# APPLICATION FOR VARIANCE

Name of project Woodland Terrace of Carmel elev. #2	State project number	County
Site address (number and street, city, state, and ZIP code) 689 Pro Med Drive, Carmel, IN 46032		
Type of project: <input checked="" type="checkbox"/> New <input type="checkbox"/> Addition <input type="checkbox"/> Alteration <input type="checkbox"/> Change of occupancy <input type="checkbox"/> Existing

GENERATED ON: 10/15/14 BR: MDE  
 UNITS: 010  
 DRAWING: M-0642441  
 DESCRIPTION: HOISTWAY  
 SHEET: 1 of 16

INTERDESIGN  
 By: DAW Date: 10/31/14

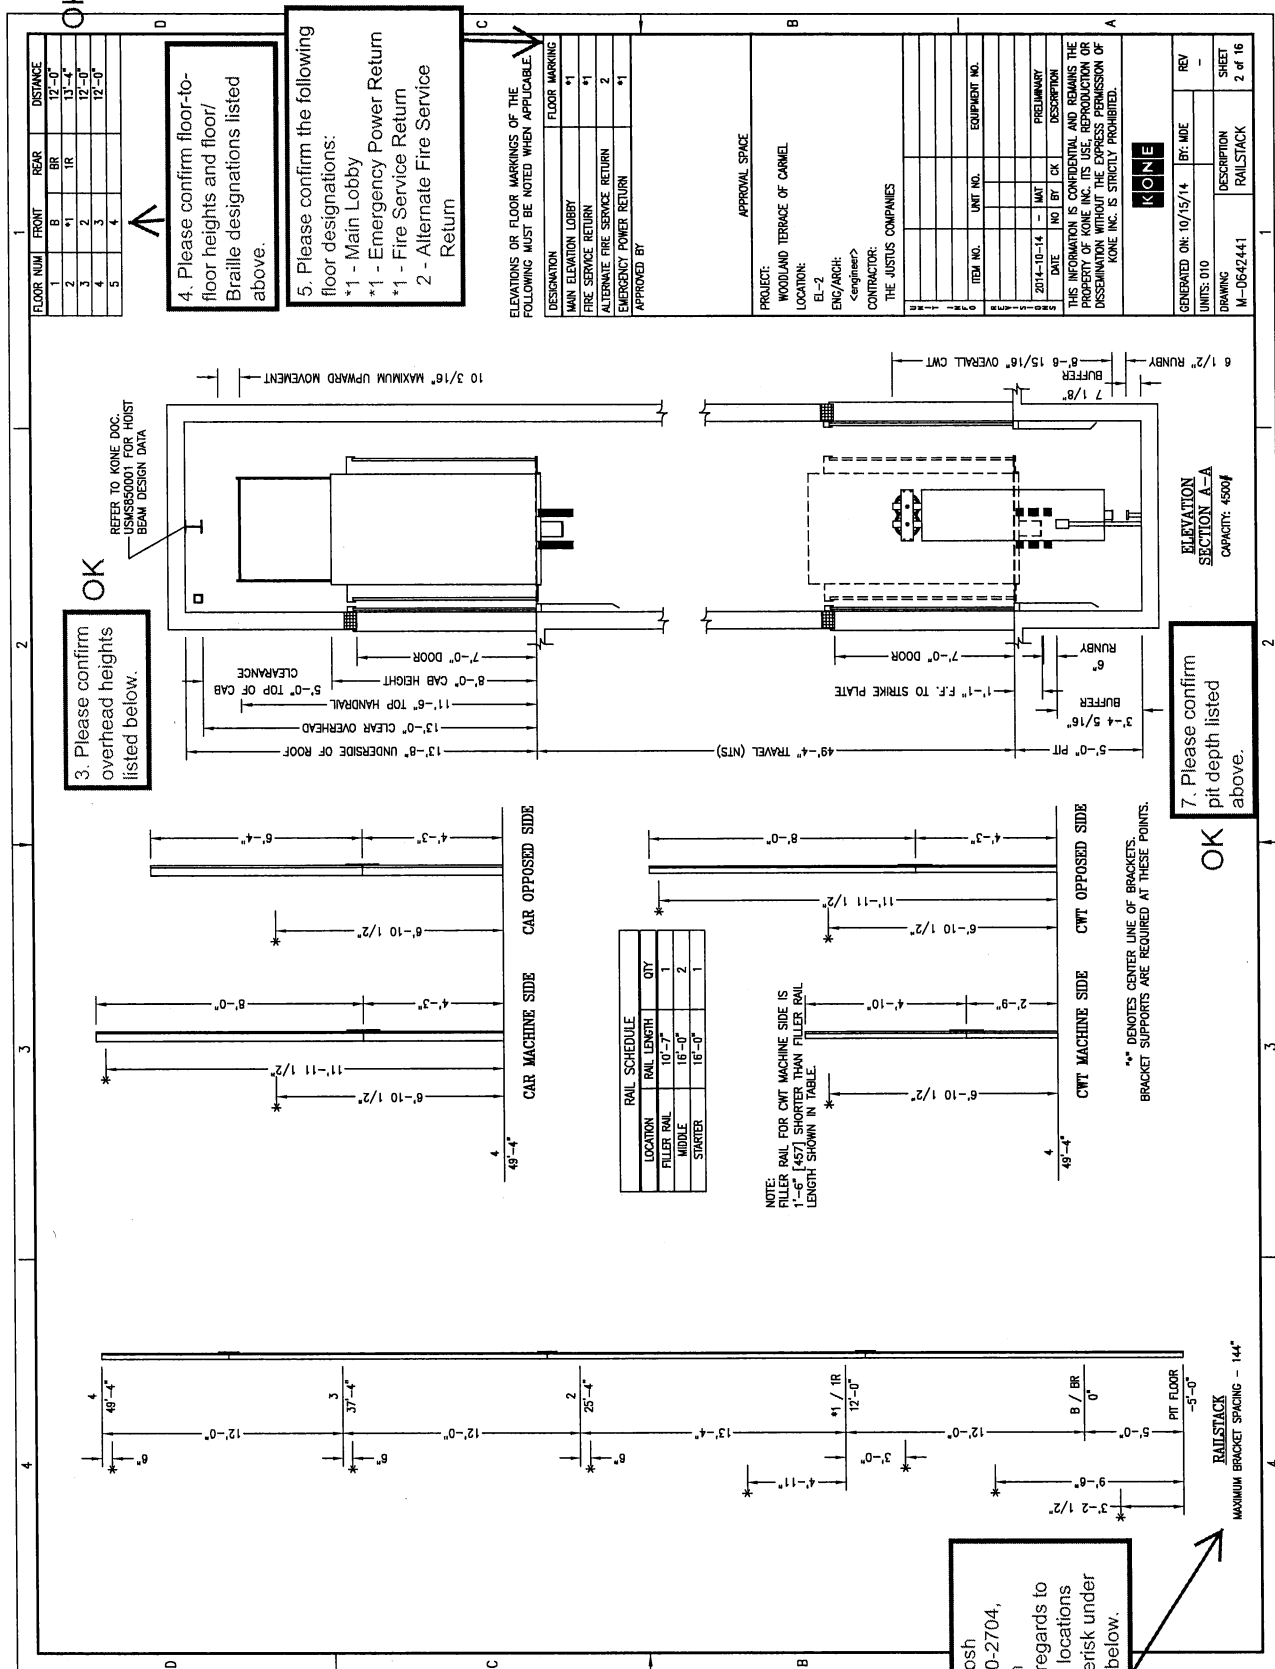
1. Please note the dimensions shown are required to properly fit the elevator equipment.

2. Please confirm the hand of door of the elevator entrances.

3. Please confirm overhead heights listed below.

OK

OK

GENERATED ON: 10/15/14 BR: WIDE REV: -  
 UNITS: 010 DESCRIPTION: RAILSTACK SHEET: 2 of 16  
 DRAWING: M-0642441

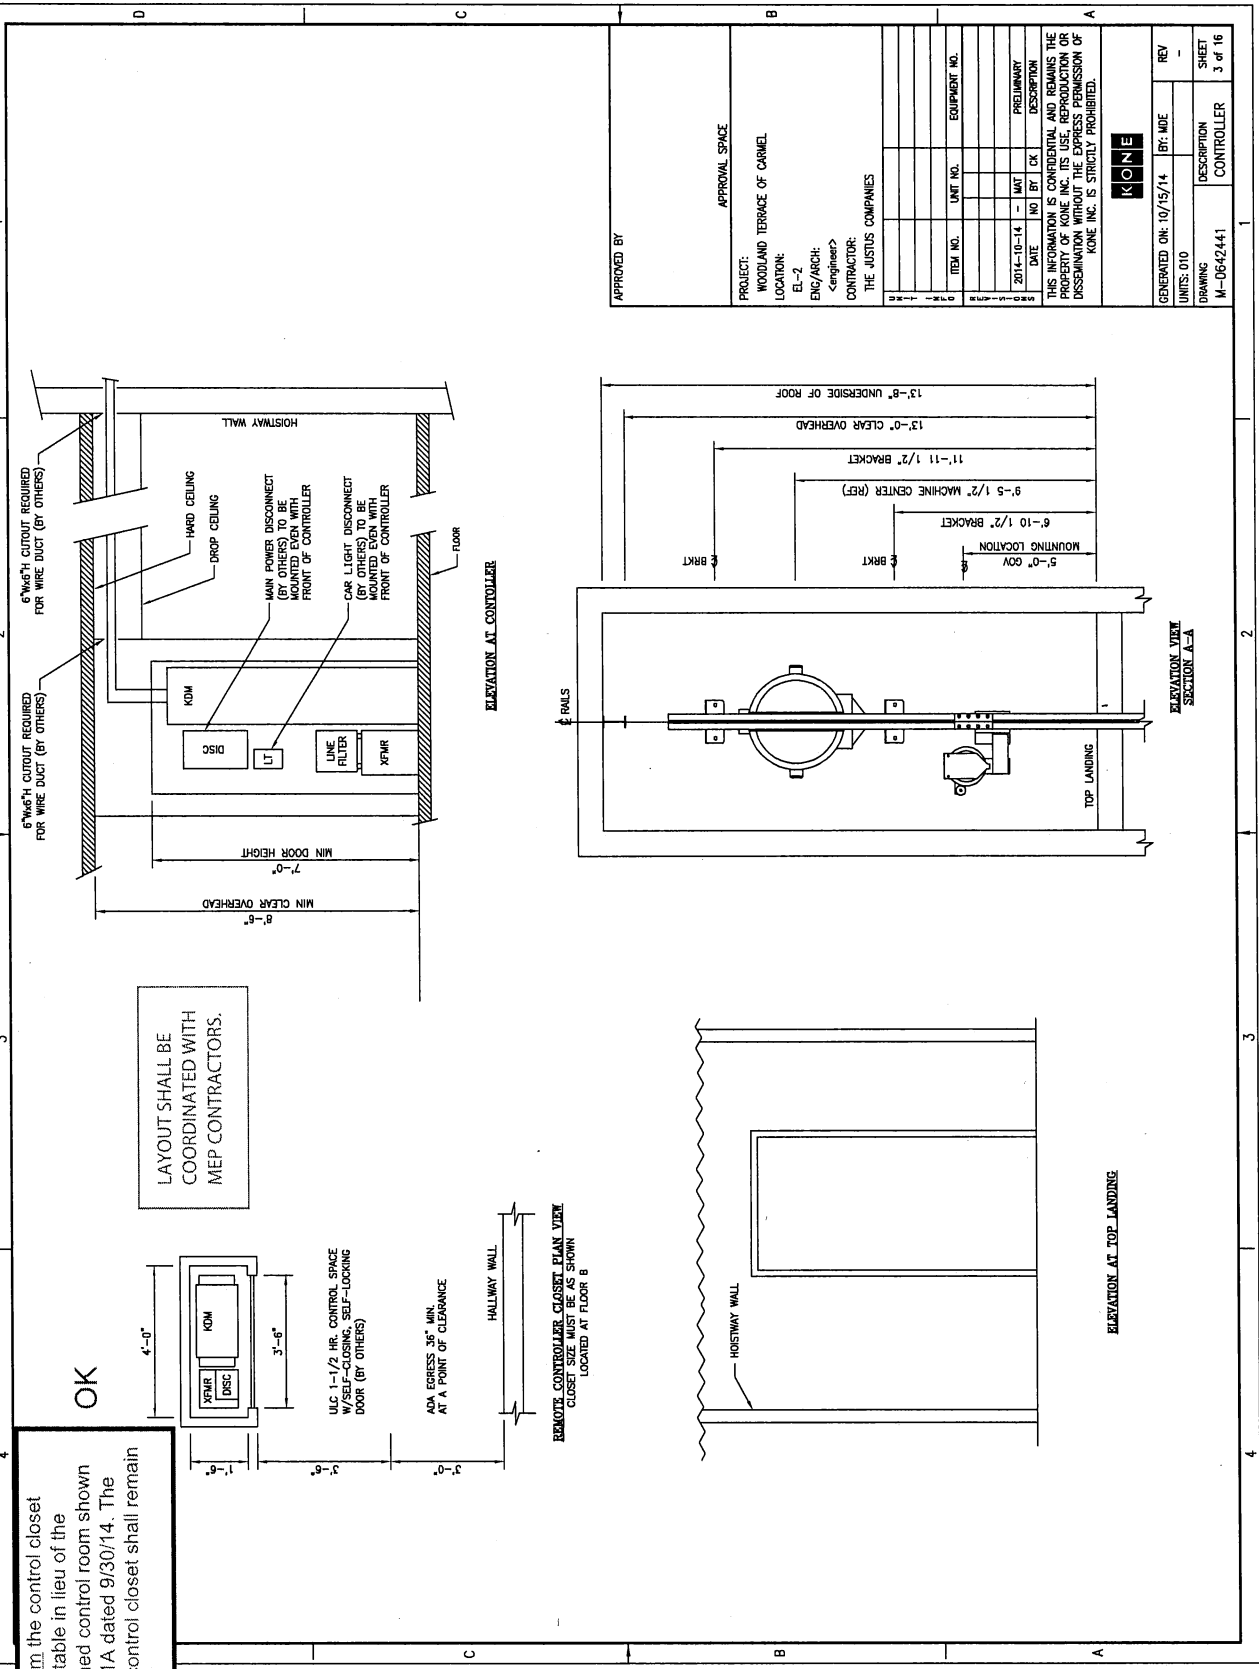
4. Please confirm floor-to-floor heights and floor/Braille designations listed above.

5. Please confirm the following floor designations:  
 \*1 - Main Lobby  
 \*1 - Emergency Power Return  
 \*1 - Fire Service Return  
 2 - Alternate Fire Service Return

6. Please contact Josh VanSickle (317) 710-2704, KONE Construction Superintendent, in regards to bracket attachment locations indicated by an asterisk under RAILSTACK detail below.

7. Please confirm pit depth listed above.

GENERATED ON:	10/15/14	BY:	MDE	REV	-
UNITS:	010	DESCRIPTION:	CONTROLLER	SHEET	3 of 16
DRAWING:	M-0662441	CONTROLLER

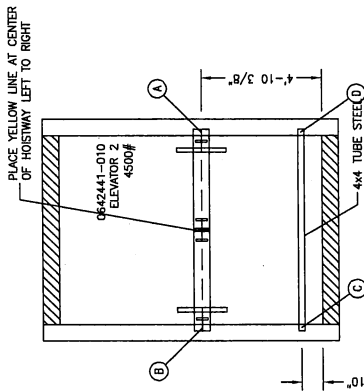
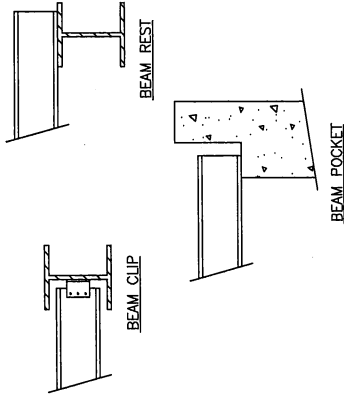
8. Please confirm the control closet design is acceptable in lieu of the currently designed control room shown on drawing A2.1A dated 9/30/14. The location of the control closet shall remain as designed.

OK

GENERATED ON: 10/15/14  
UNITS: 010  
DRAWING: C-0642441  
DESCRIPTION: CAB  
REV: -  
SHEET: 8 of 16

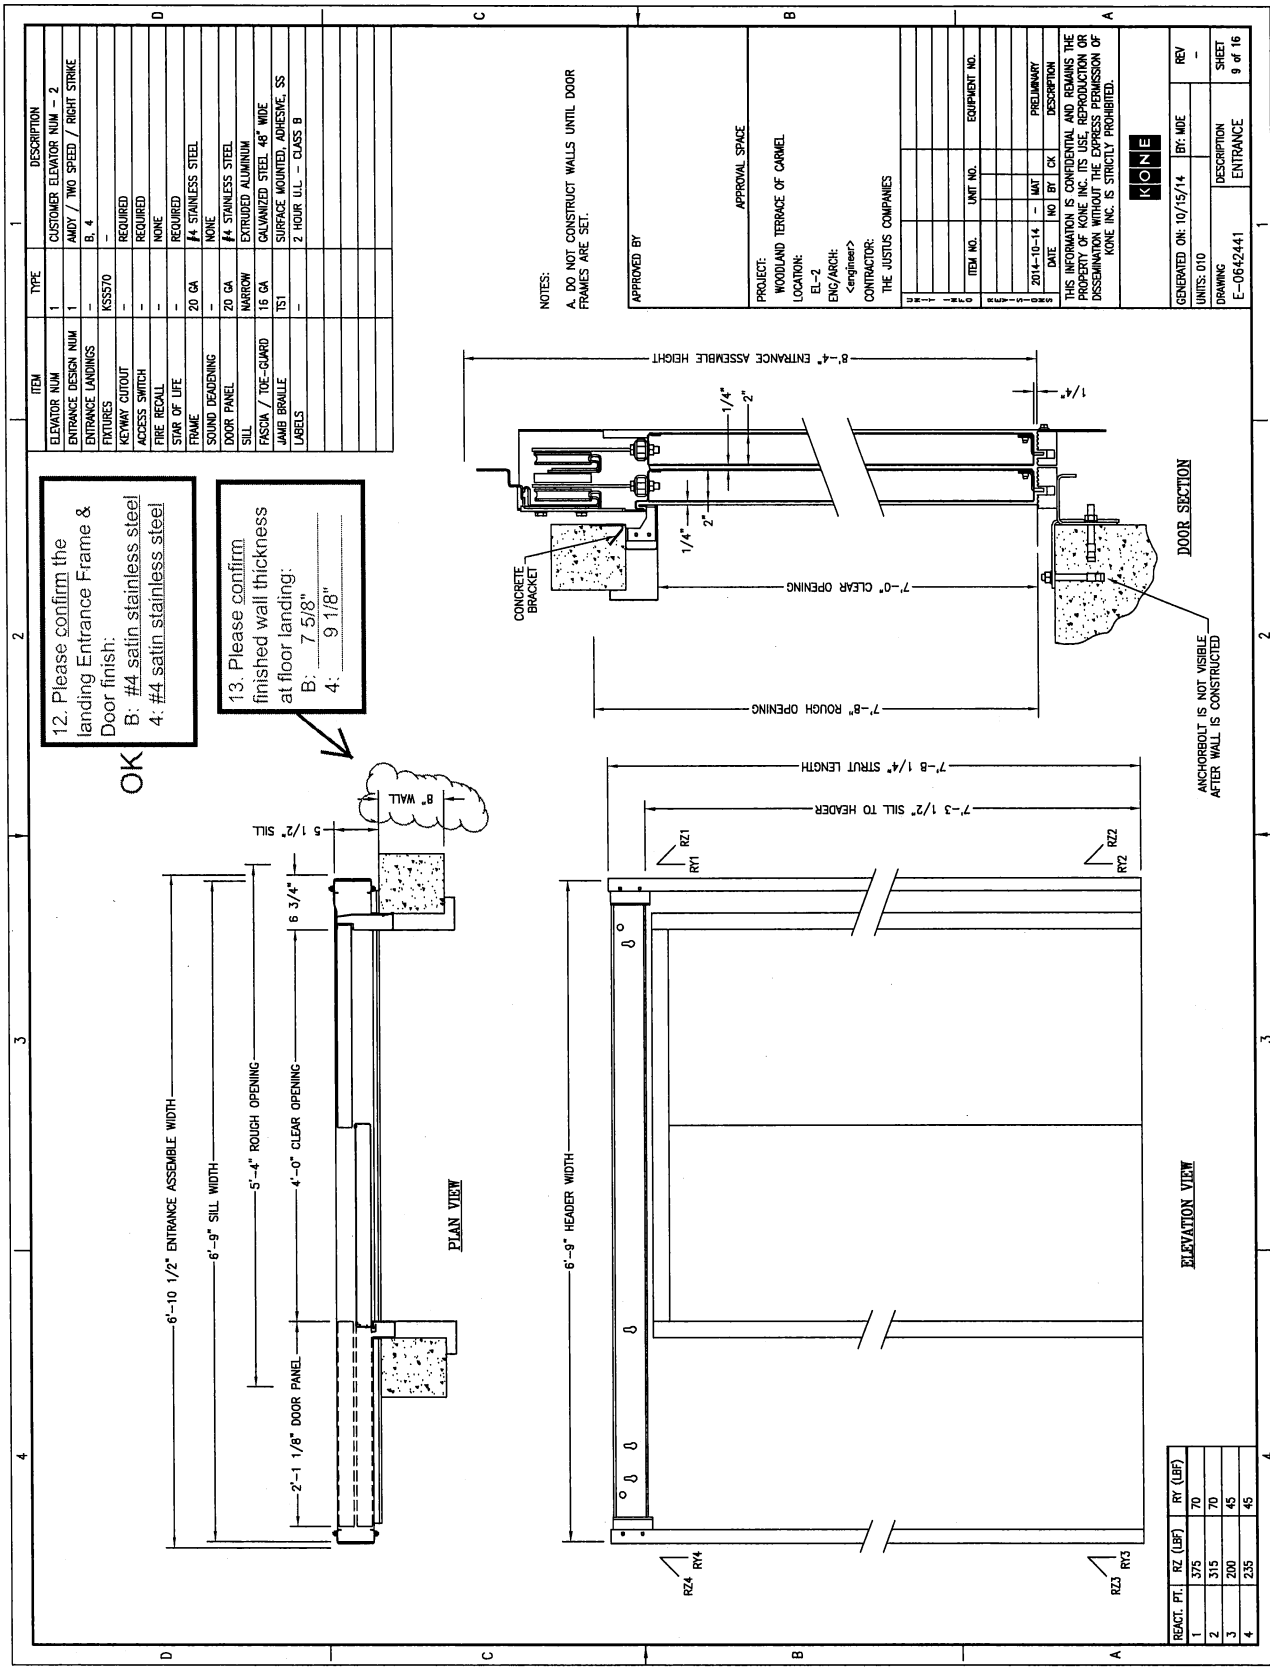
11. Please select a plastic laminate color from our standard choices available:  
Amber Cherry 7919-38

KONE	
GENERATED ON: 10/15/14	BY: MDE
UNITS: 010	REV
DRAWING: E-0642441	DESCRIPTION: ENTRANCE
	SHEET: 10 of 16

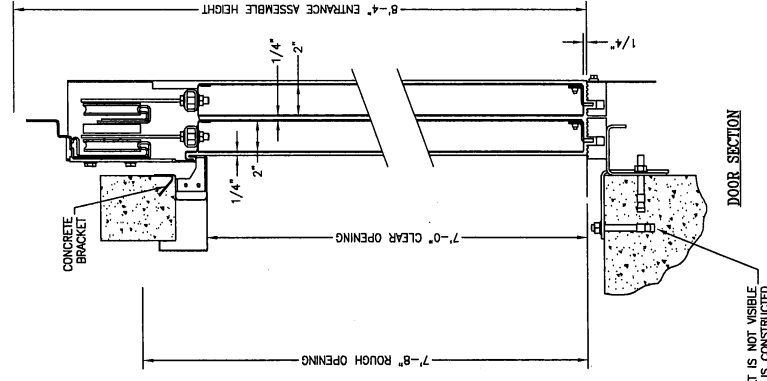
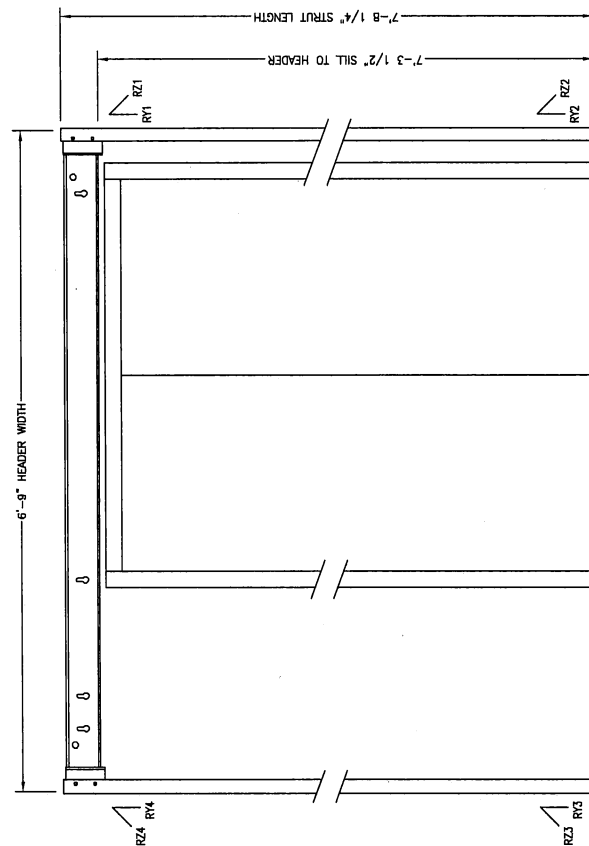
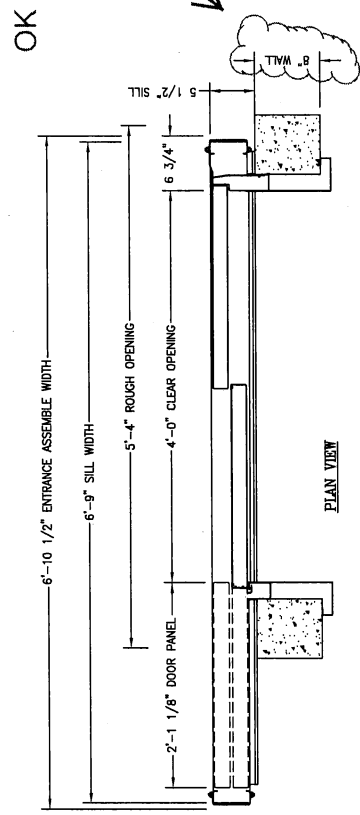
14. Please confirm the landing Entrance Frame & Door finish:  
 \*1: #4 satin stainless steel  
 2: #4 satin stainless steel  
 3: #4 satin stainless steel

15. Please confirm finished wall thickness at floor landing:  
 \*1: 7 5/8"  
 2: 9 1/8"  
 3: 9 1/8"

OK

GENERATED ON: 10/15/14	BY: WIDE	REV: -
UNITS: 010	DESCRIPTION: ENTRANCE	SHEET: 11 of 16
DRAWING: E-064241

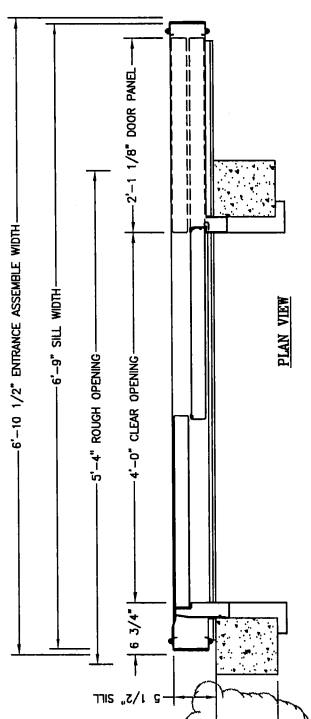
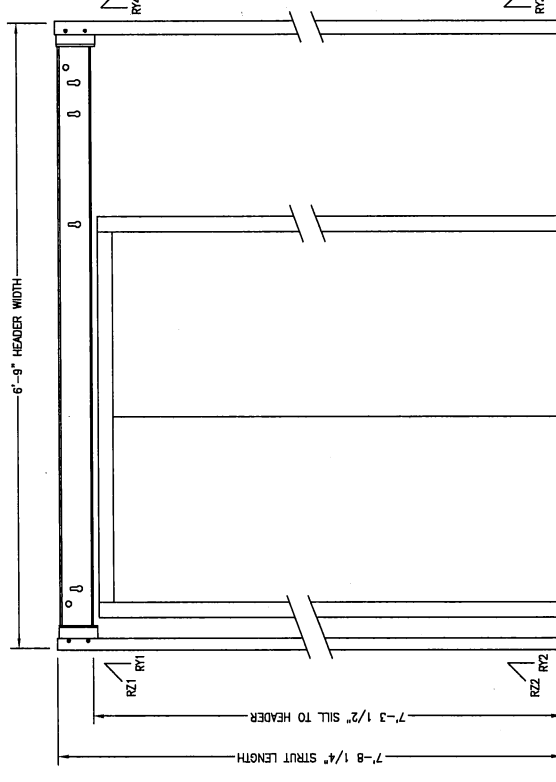
16. Please confirm the landing Entrance Frame & Door finish:  
BR: #4 satin stainless steel

17. Please confirm finished wall thickness at floor landing:  
BR: 2' - 6 7/8"

OK

GENERATED ON: 10/15/14 BY: MDE  
 UNITS: 010  
 DRAWING: E-0642441 DESCRIPTION: ENTRANCE SHEET: 12 of 16

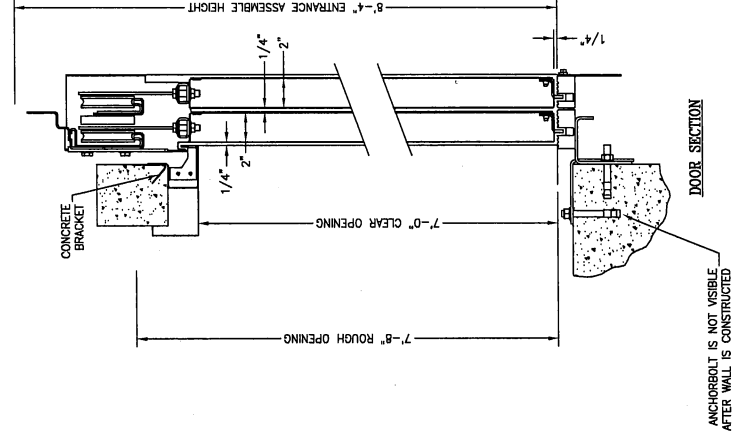
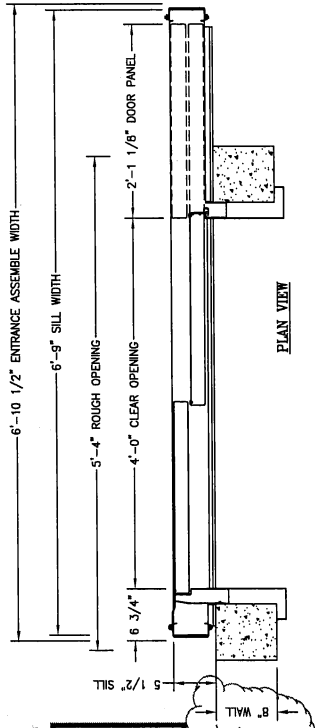
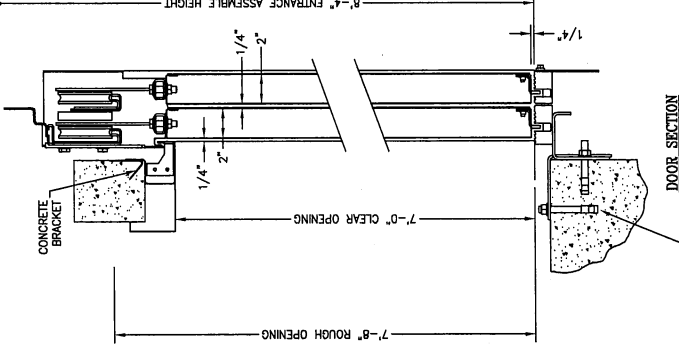
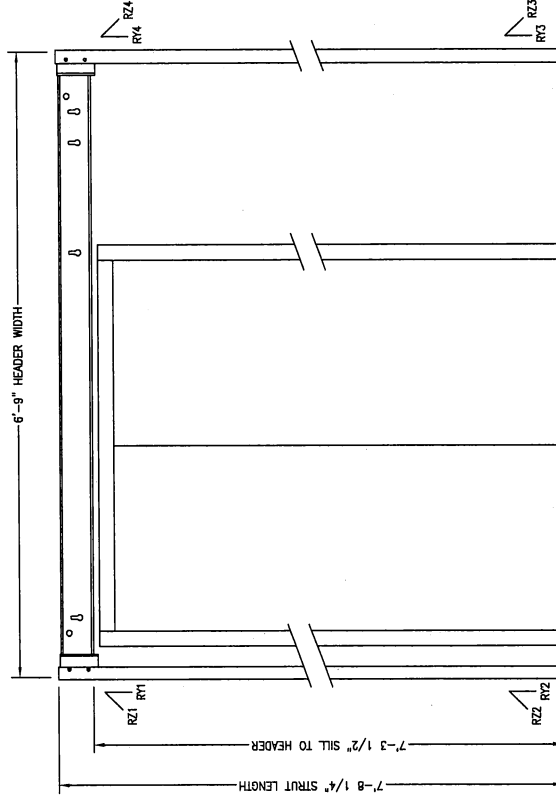
18. Please confirm the landing Entrance Frame & Door finish:  
1R: #4 satin stainless steel

19. Please confirm finished wall thickness at floor landing:  
1R: 2' - 5 3/8"

OK
